806 US Route 1 Bypass
Project Description

RE: Site Plan Approval for property located at 806 US Route 1 Bypass, Tax Map 161, Lot 43 (LU-22-81)

I am writing in response to your TAC letter dated May 9th, 2022. Your concerns are italicized with our comments below in bold.

Site Plan Review

| UTILITY PLAN | | |

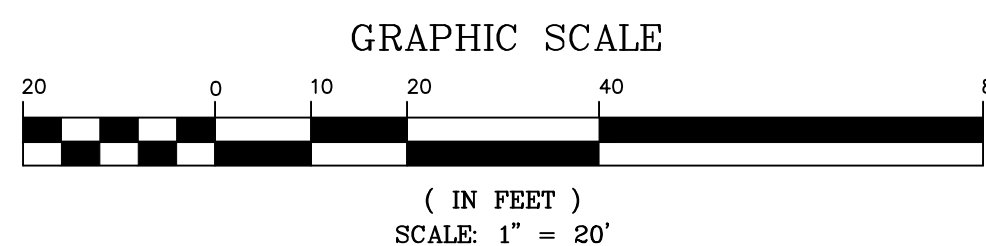
9. *Light Pole 3 (LP3) located at the rear of the building shall be limited to a height of 16' with cur off shields.*

10. *Lighting on the rear wall will not exceed a height of 9'.*

Note 3 has been added to the utility plan.

Note 3 has been added to the utility plan.

LANDSCAPE PLAN

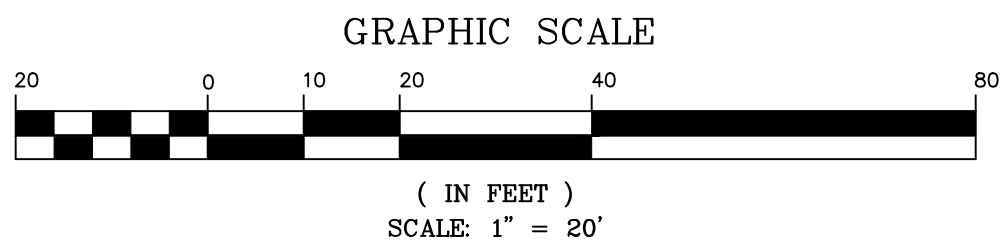
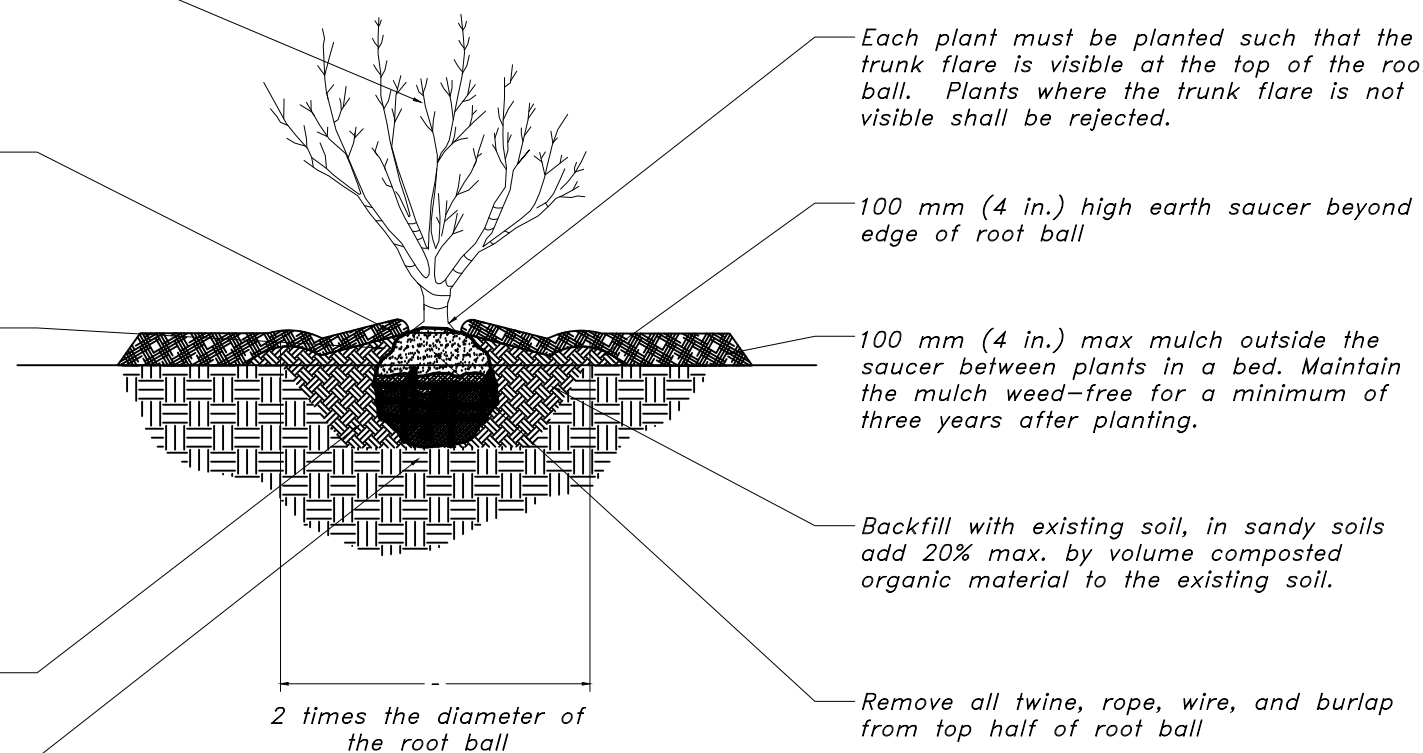
2. *A note will be added to the plans regarding the use of non-combustible mulch.*

Note 9 has been added to the landscape plan.

- MULCH USED WILL BE NON-COMBUSTIBLE OR APPROVED BY THE PORTSMOUTH FIRE DEPARTMENT.
